List of changes from consented scheme:

North	Architect / Originator: Tate Harmer	Unit G1B2, Stamford Works, 3 Gillett Street, London N16 8JH Tel: +44 (0)207 241 7481 Email: studio@tateharmer.com	Do not scale. All dimensions to be checked on site. This drawing is copyright.	
		Client: Platinum Land	8 Queripel House, 1 Duke of York Sqaure, Kings Road, London, SW3 4LY		
		Project: Belsize Park Firestation		Date of Origin: 28.11.17	Drawn By: TS
		Drawing Title: Proposed and Existing Courtyard Elevations	3	Scale/s: 1:100	
Client Sign Off		Drawing Number: BFS TH	IA PR AL 340 P3 <sub>Revision</sub>	Drawing Status: Planning

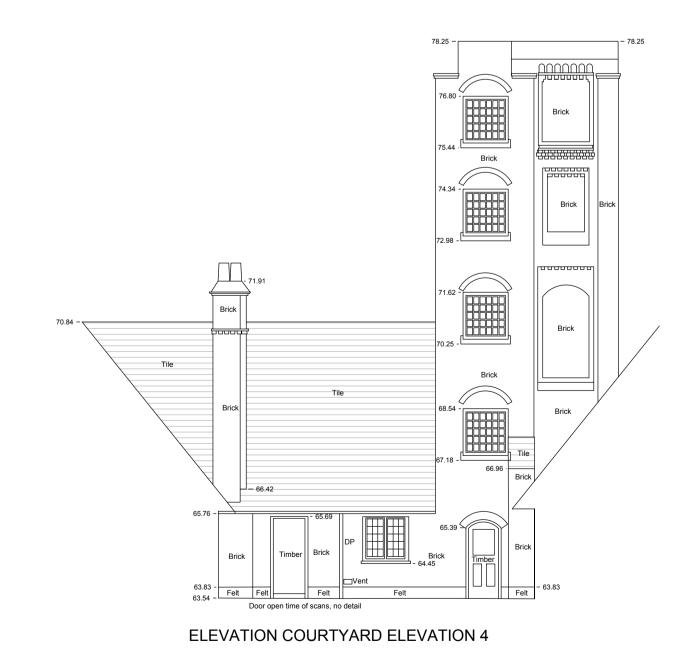
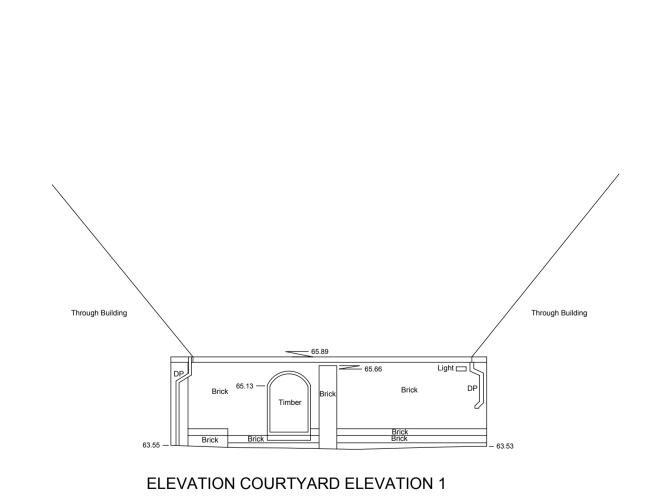
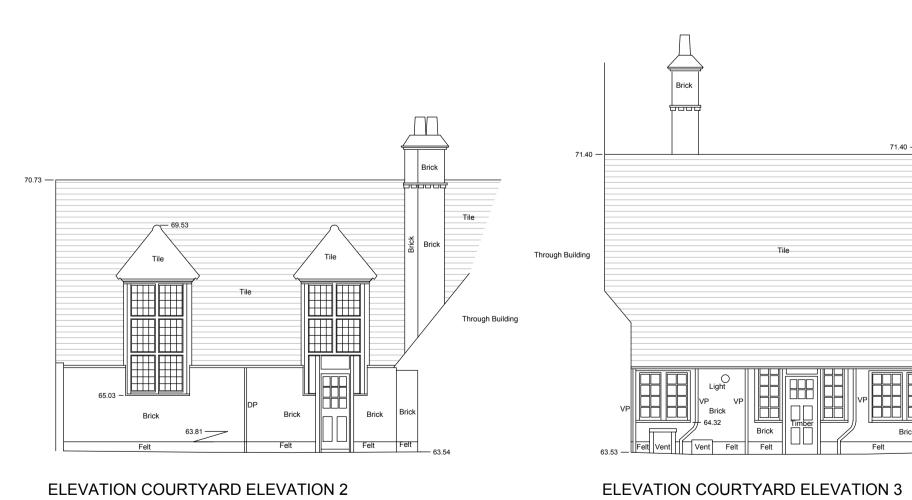
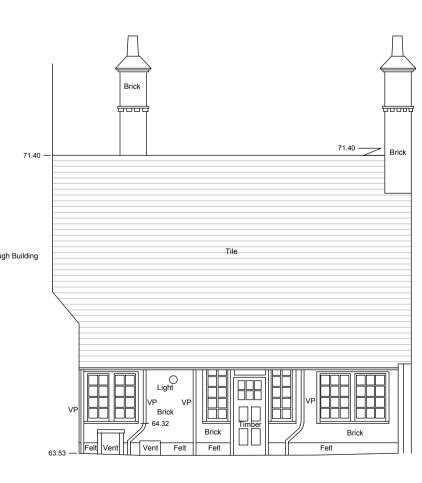
- Basement lowered by 85mm.
- Side extension lowered by 200mm.
- Dormer cheeks made to match dimensions as per existing dormer windows in courtyard.
